# UNITED STATES PATENT AND TRADEMARK OFFICE

APPLICATION NO.	FILING DATE	FIRST NAMED INVENTOR	ATTORNEY DOCKET NO.	CONFIRMATION NO.
10/661,324	09/12/2003	Bodo Ehlers	FHN-106-B	9310
7590 09/08/2005 Christopher A. Mitchell Suite 624 3001 West Big Beaver Road Troy, MI 48084-3107			EXAMINER GOLUB, MARCIA A	
			ART UNIT 2828	PAPER NUMBER

<b>Office Action Summary</b>	<b>Application No.</b> 10/661,324	<b>Applicant(s)</b> EHLERS ET AL.	
	<b>Examiner</b> Marcia A. Golub	<b>Art Unit</b> 2828

## **DETAILED ACTION**

FIG. 10A

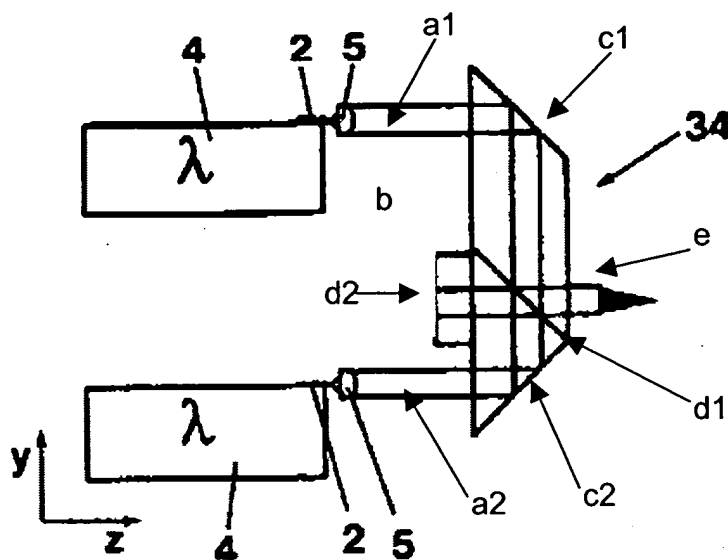
Regarding **claims 1-18** Fig 10A of Du discloses “An apparatus for shaping part of the collective output beam of a plurality of semiconductor lasers comprising individual bars of semiconductor lasers [2] stacked one on top of the other to form an array, the plurality of semiconductor lasers being arranged to define a plurality of light-emitting areas [a1, a2] and a plurality of non-light- emitting areas [b], and the array having dimensions in X, Y and Z axes, wherein the Y axis defines a fast axis, the X axis defines a slow axis, and the Z axis defines an axis of propagation for the output beam, the apparatus comprising:

a first reflective member [c] comprising at least a first reflective element [c1] positioned a fixed distance from each bar in the array, the at least first reflective element adapted to deflect a first portion [a1] of the output beam from each bar in the array in a first direction [-y direction] oriented at a first angle [0 degrees] in the slow axis direction and at a second angle [90 degrees] in the fast axis direction,

at least a second reflective member [d] comprising at least a first reflective element [d1] positioned a fixed distance from each bar in the array, the at least first reflective element of the second reflective member adapted to deflect the first portion of the output beam from each bar from the first direction [-y direction] to a second direction [z direction] oriented in the Z axis direction;

and whereby the first portion [e] of the output beams of each bar in the array are oriented approximately parallel to the un-deflected remainder [a1] of the output beams

of each bar, and the non-light-emitting areas are substantially eliminated from the output beams. [two light beams are combined into one light beam]

wherein: the first reflective member [c] further comprises a second reflective element [c2] positioned a fixed distance from each bar in the array, the second reflective element adapted to deflect a second portion [a2] of the output beam from each bar in a third direction [y direction] oriented at a third angle in the slow axis [0 degrees] direction and at a fourth angle [90 degrees] in the fast axis direction;

the at least second reflective member [d] comprising a second reflective element [d2] positioned a fixed distance from each bar in the array, the at least second reflective element [d2] of the second reflective member [d] adapted to deflect the second portion [a2] of the output beam of each bar from the third direction [y direction] to a fourth direction [z direction] in the Z axis direction;

and whereby the first portion and second portion [e] of the output beams of each bar in the array are oriented approximately parallel to the un-deflected remainder [a1,a2] of the output beams of each bar, and the non-light-emitting areas are substantially eliminated from the output beams [two light beams are combined into one light beam];

wherein the third direction [y direction] is approximately opposite the first direction [-y direction], the first and third angles are approximately the same [0 degrees], the second and fourth angles are approximately the same [90 degrees], and the second and fourth directions are approximately the same [z direction];

further comprising at least one optical member [5] adapted to balance the optical path length of the un-deflected remainder [a1, a2] of the output beam of at least one of the bars in the array, the at least one optical member being disposed at a fixed position in the axis of propagation of the un-deflected remainder of the output beam;

wherein the total height of the first and second reflective members corresponds to the pitch of the semiconductor lasers in the array [reflective members c and d encompass all the light produced by laser bars 2];

wherein the output beams [a1, a2] of each bar in the array are propagated in a direction substantially perpendicular to a plane defined by the X and Y axes." [output beams are propagating in the z direction, which is perpendicular to the xy-plane]
